**RE: CYPRESS WOODS RVPD
DCI2023-00030**

Enclosed please find responses to Staff's comments dated September 21, 2023. Accordingly, the following items are provided to address Staff's sufficiency review comments:

Cypress Woods RV Resort RVPD Amendment Request Statement and Lee Plan Compliance Narrative

MASTER CONCEPT PLAN

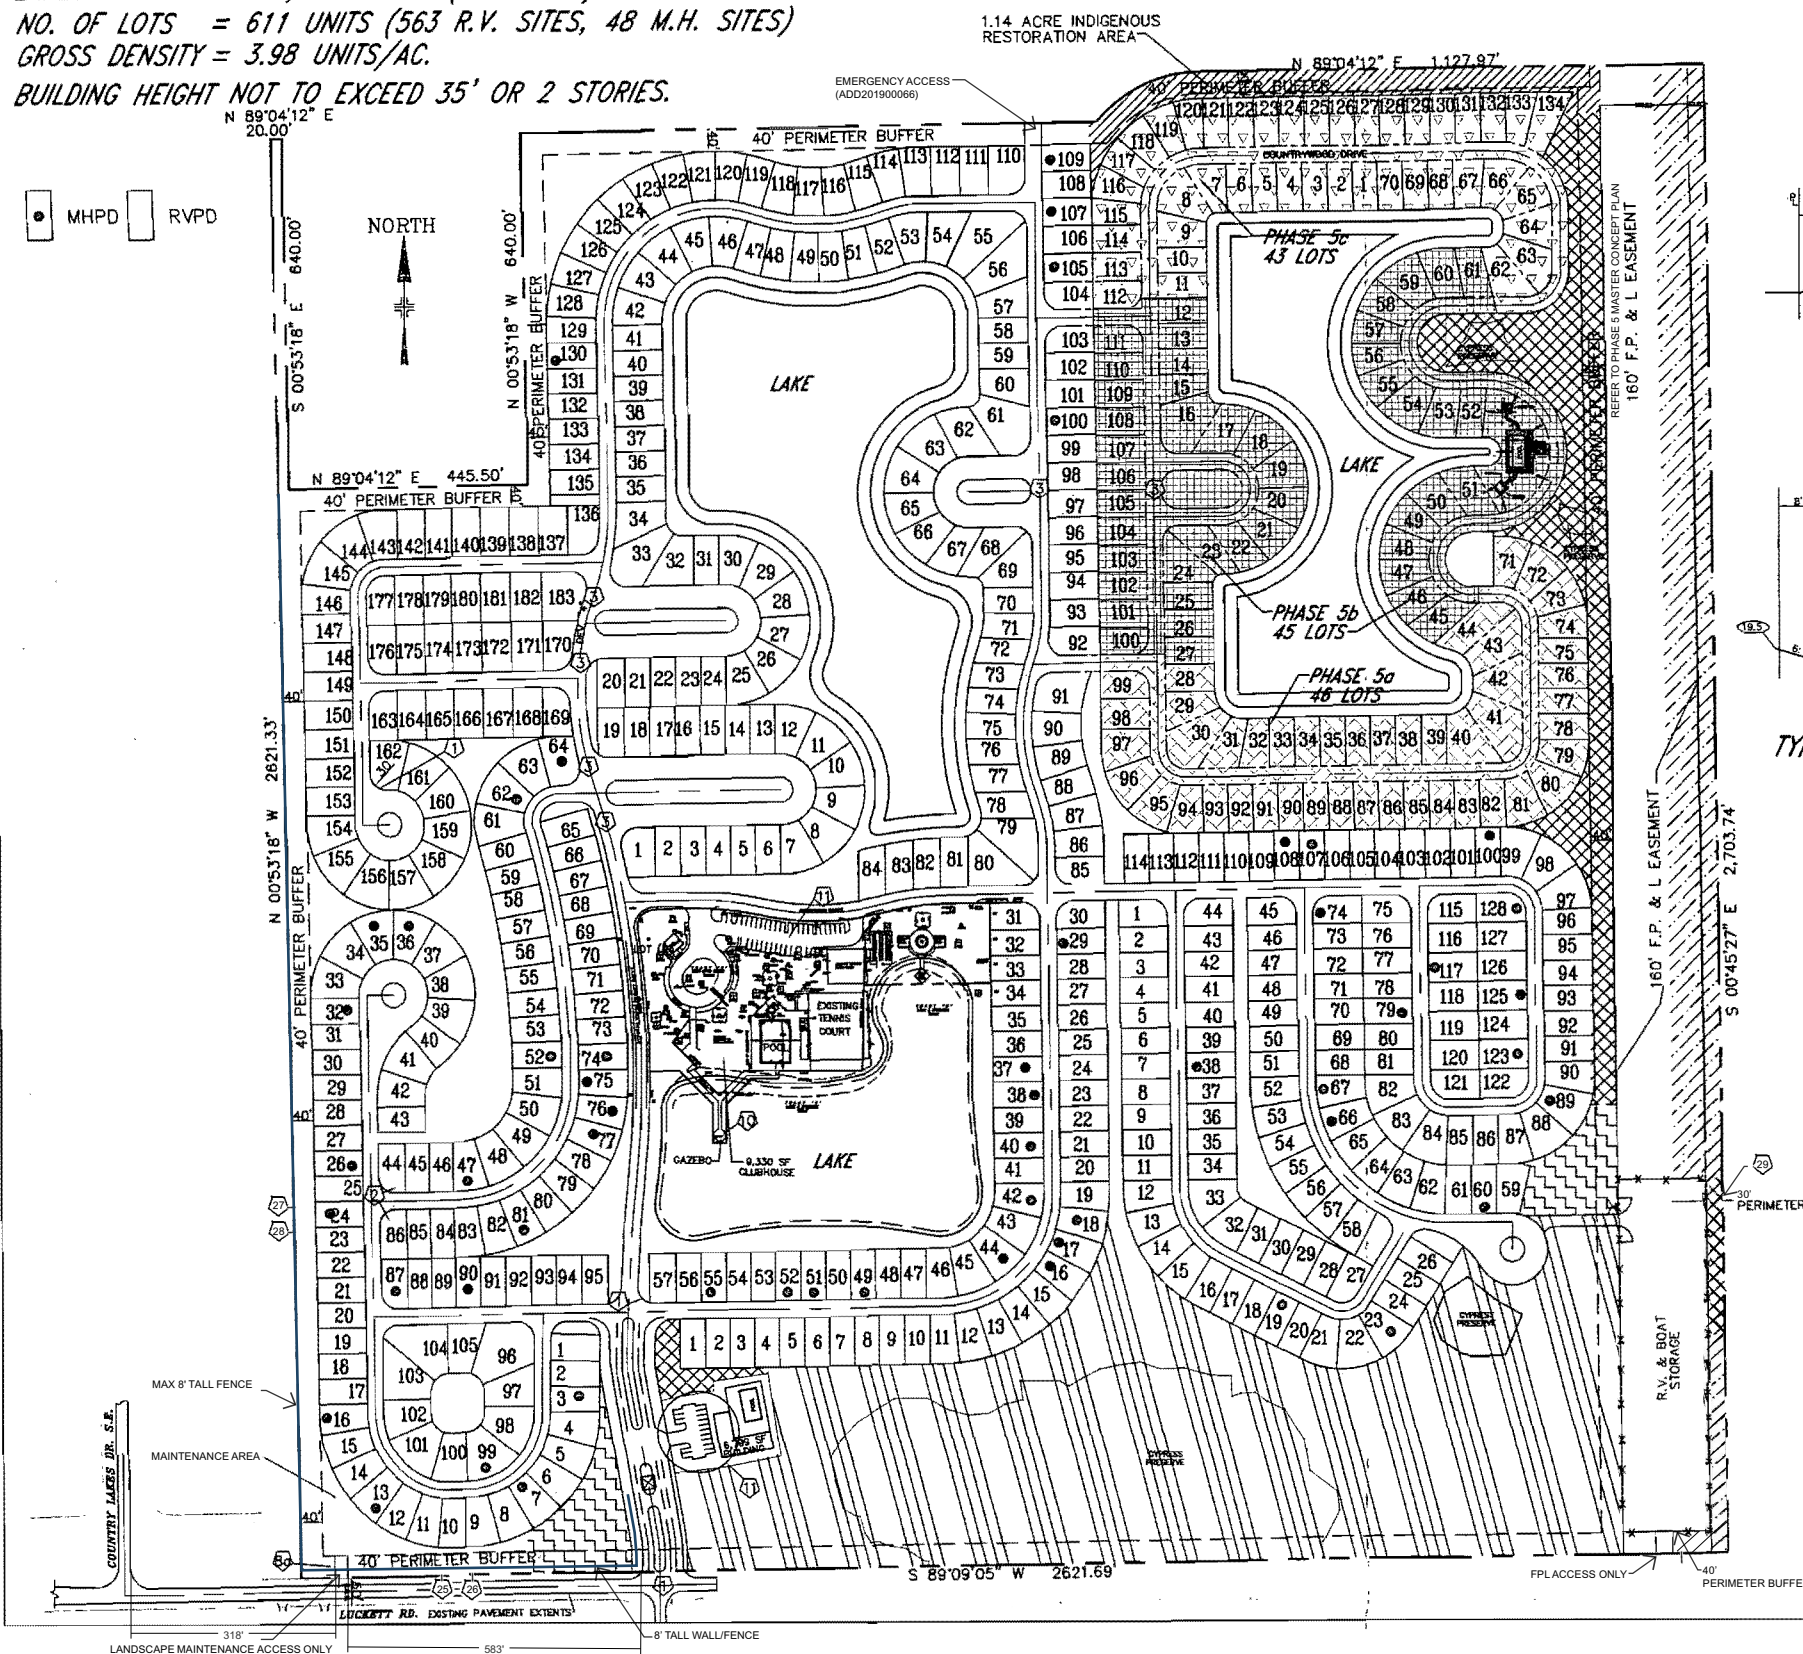
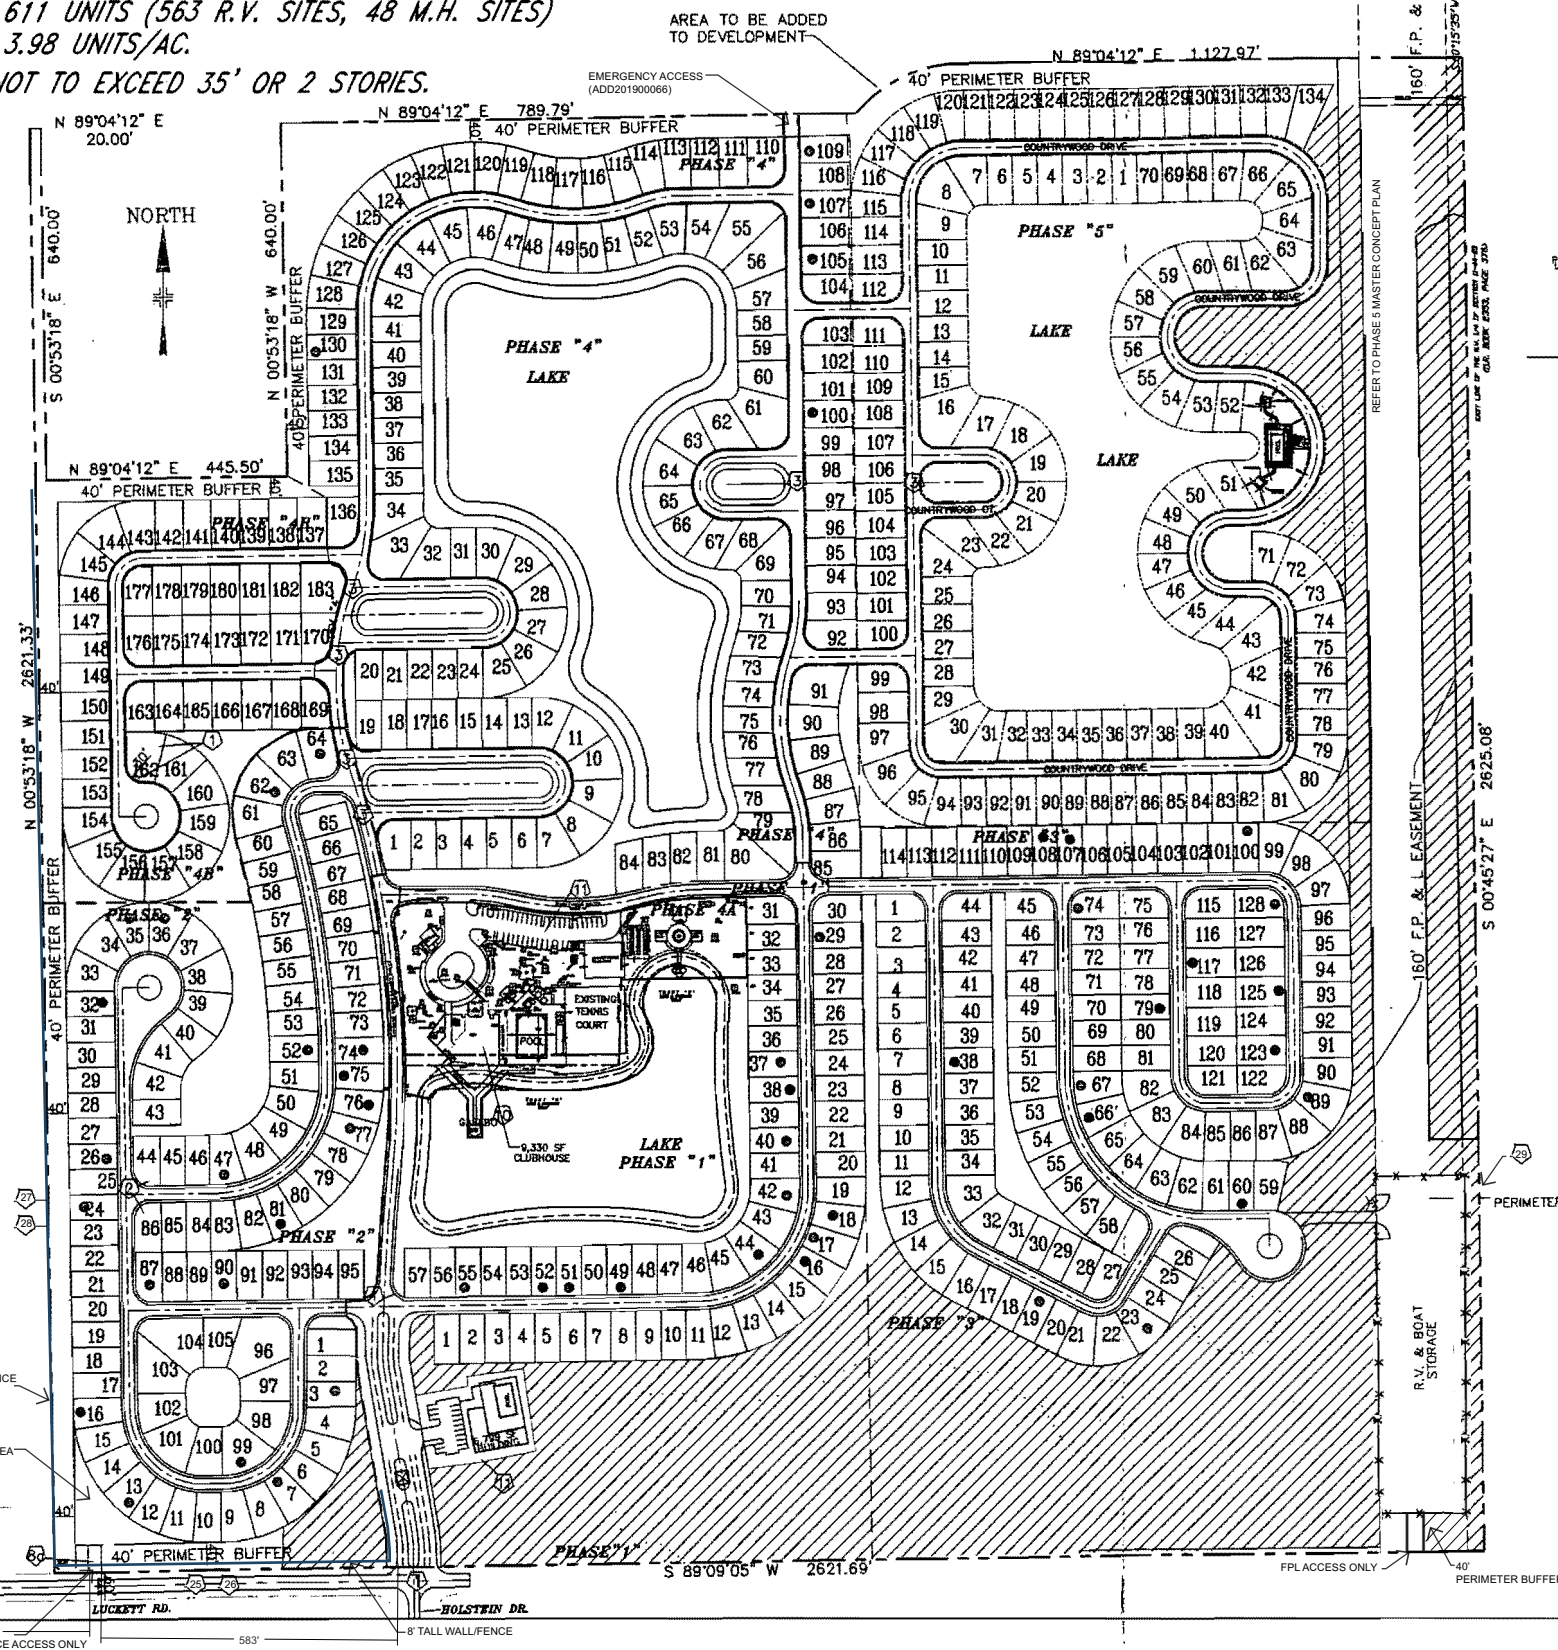
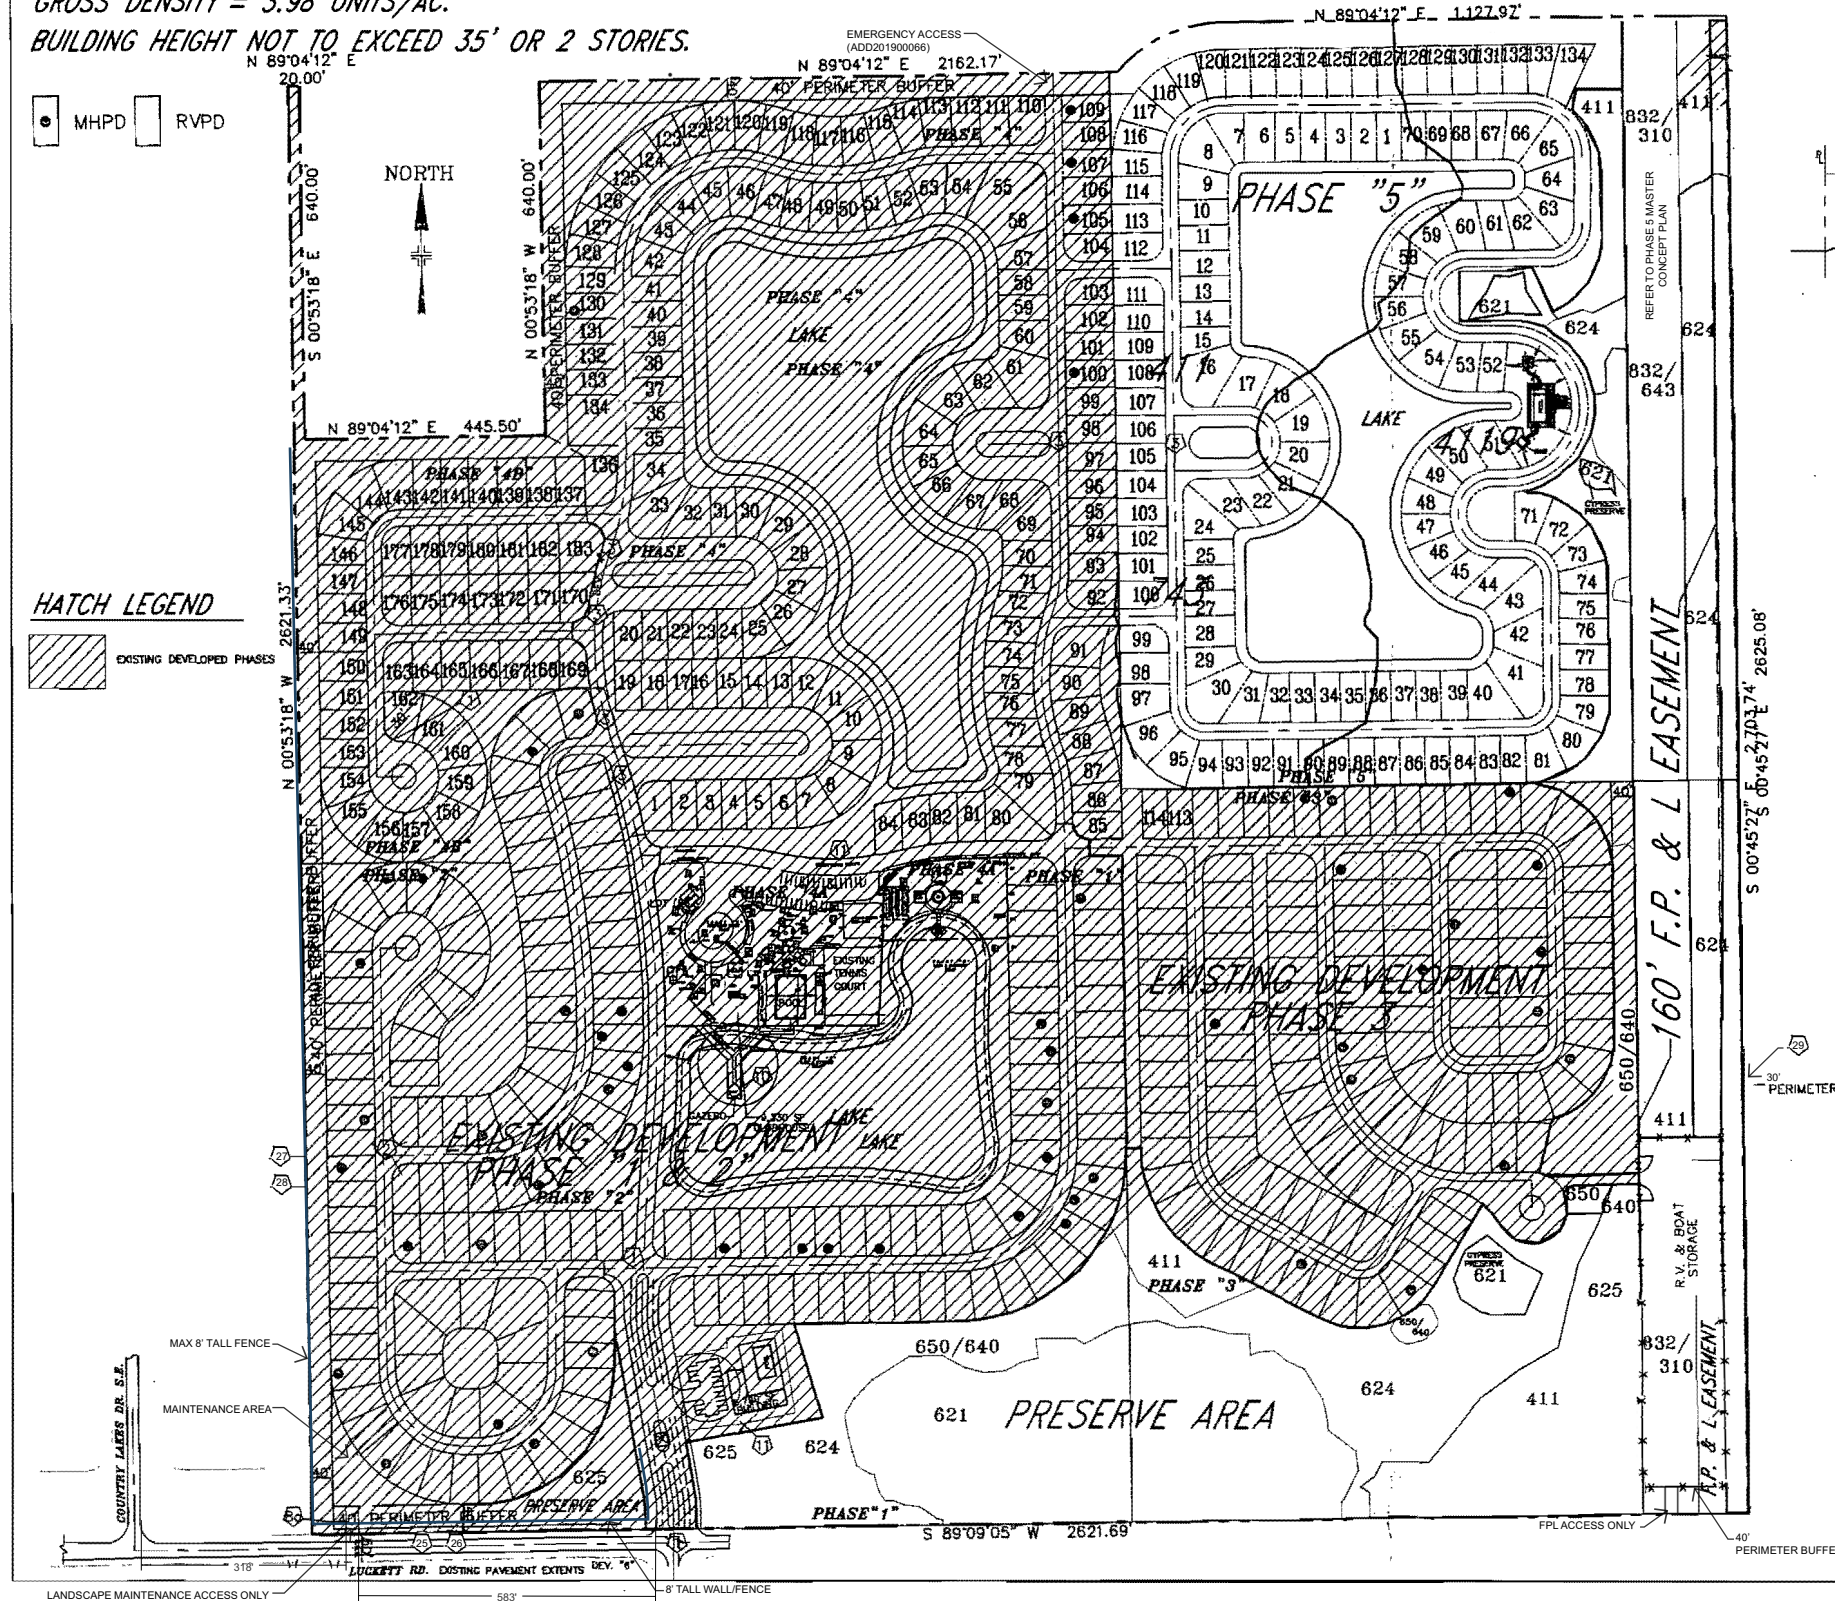
3. Deviation 31 may affect open space. Please provide an updated open space chart on the MCP.

1. Please show the distances between the proposed project's entrance and the adjacent streets/driveways on LUCKETT RD in the MCP per LDC §10-285.

RESPONSE: Deviation 31, now Deviation 30, would not affect the total open space requirement as calculated MCP. This deviation is particular to setbacks of individual structures within lots 3-9 in Phase 1 and lots 87-99 in Phase 3 which are not used to calculate open space. With the expansion of the storage area there is only a reduction of FPL Easement Open Space has been reflected on the MCP as well as the reduction in Indigenous Open Space. Open space still remains above the 40% required for this site at 43.11% open space.

RESPONSE: See revised MCP with distances shown.

Figure 6. FLUCCS Map

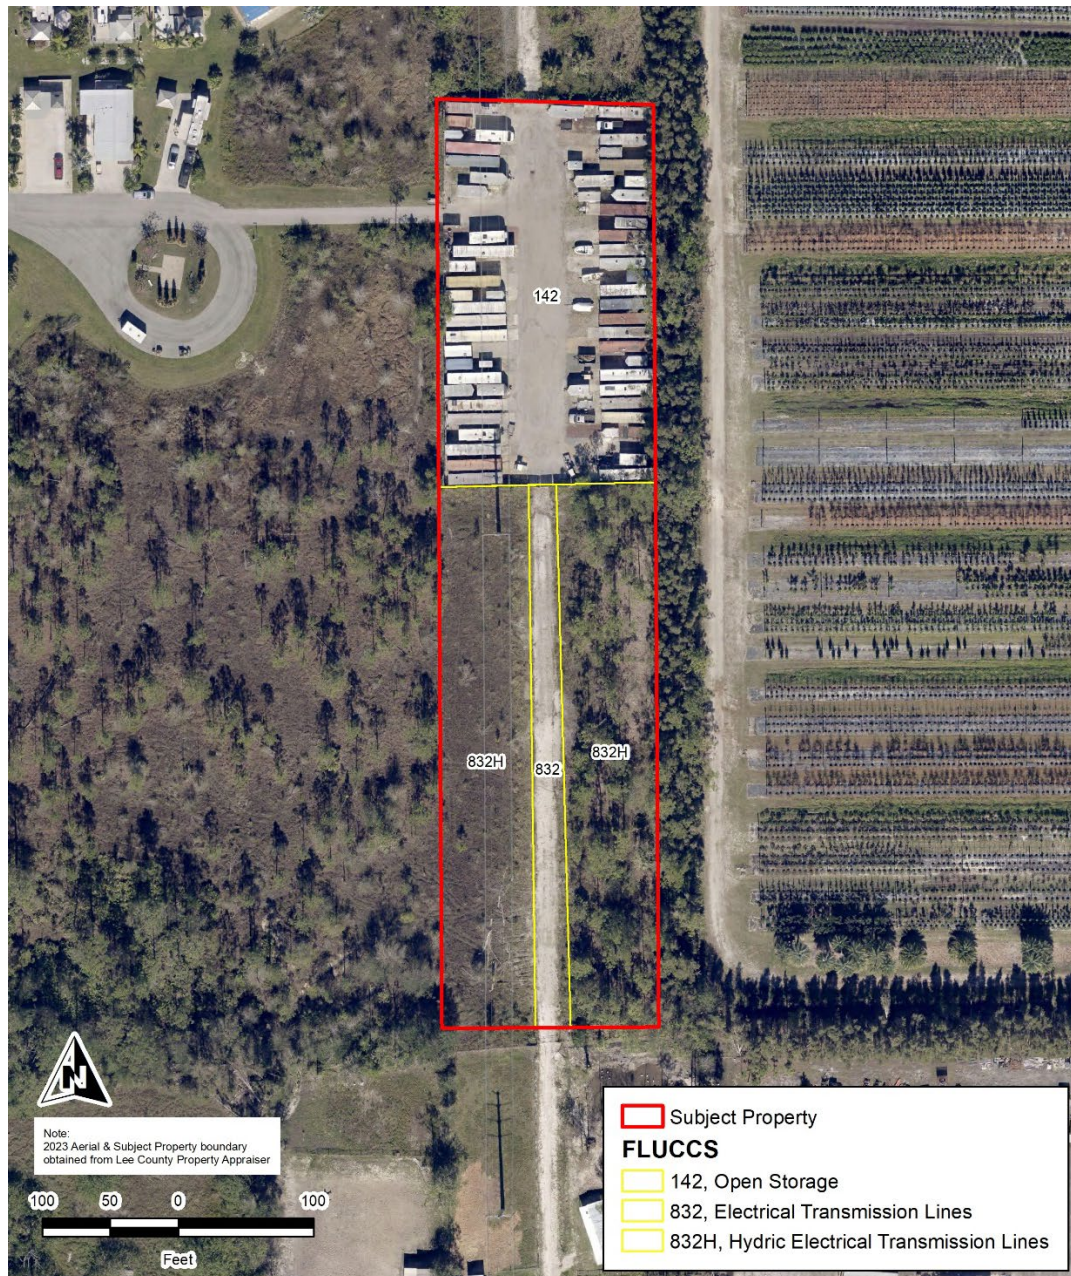
1. The submittal waiver request for the FLUCCS map and Listed Species survey was not granted. Please provide the required documents per LDC 34-373.

RESPONSE: The FLUCCS map, Listed Species survey and required documents per LDC-34-373 has been provided for RV & Boat storage area to be expanded. The PD Amendment request does not impact any other areas that have not already been developed.
